Abnormal Chirp or Squeak Noise from High Pressure Fuel Pump

Service Category Engine/Hybrid System

Section Fuel System

YEAR(S)	MODEL(S)	ADDITIONAL INFORMATION
2013	FR-S

Figure 1.

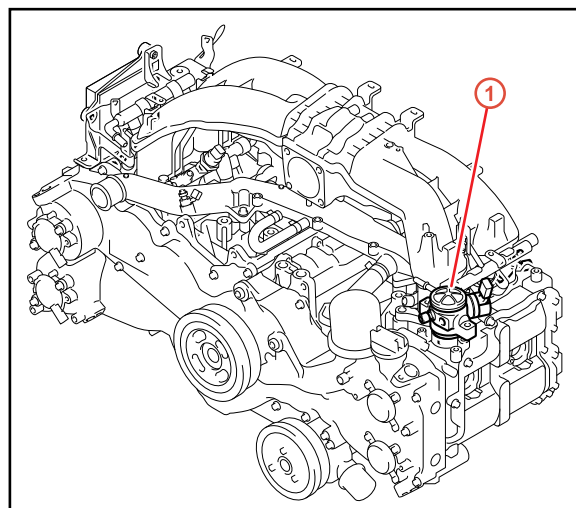
1. Road test the vehicle for at least 10 minutes so that the engine is fully warmed up.
2. While the engine is idling, listen for abnormal noise from the High Pressure Fuel Pump Assembly.

- A mechanical ticking noise from the High Pressure Fuel Pump Assembly is normal during Direct Injection system operation.
- This bulletin should only be performed if an abnormal high pitch chirp or squeak noise from the High Pressure Fuel Pump is verified.

4. Replace the High Pressure Fuel Pump Assembly.
